UNITED STATES PATENT AND TRADEMARK OFFICE

Office Action Summary	Application No. 10/520,903	Applicant(s) ISNARD ET AL.	
	Examiner WILLIAM K. CHEUNG	Art Unit 1796

DETAILED ACTION

Figure 1

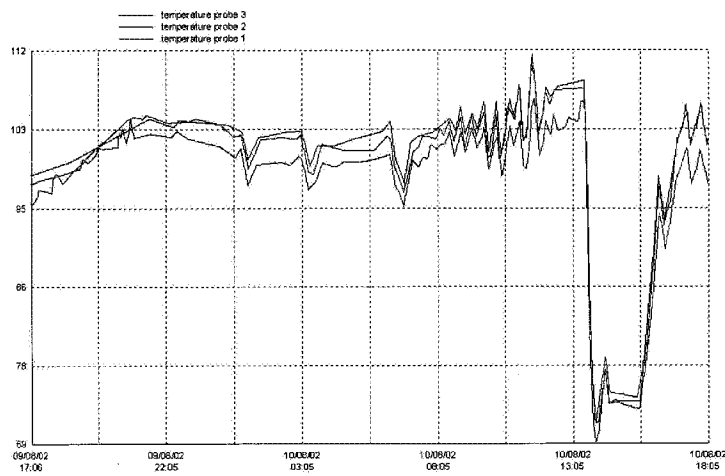
Regarding applicants' argument that Figures 1 and 2 provide the contrast between a process that has been rinsed (Figure 1) and a process that has not been rinsed (Figure 2), applicants fail to recognize that Figures 1 and 2 fail to provide the criticality of the claimed invention, which requires the pressurizing the reactor, by providing comparative data that are commensurate to the scope of the claimed invention and the art relied on for the rejection. Applicants must recognize that the difference between the claimed invention and the invention of Wirth is the pressurization

of reactor for preparing a reactor for a polymerization process, not with or without rinsing with hexane.
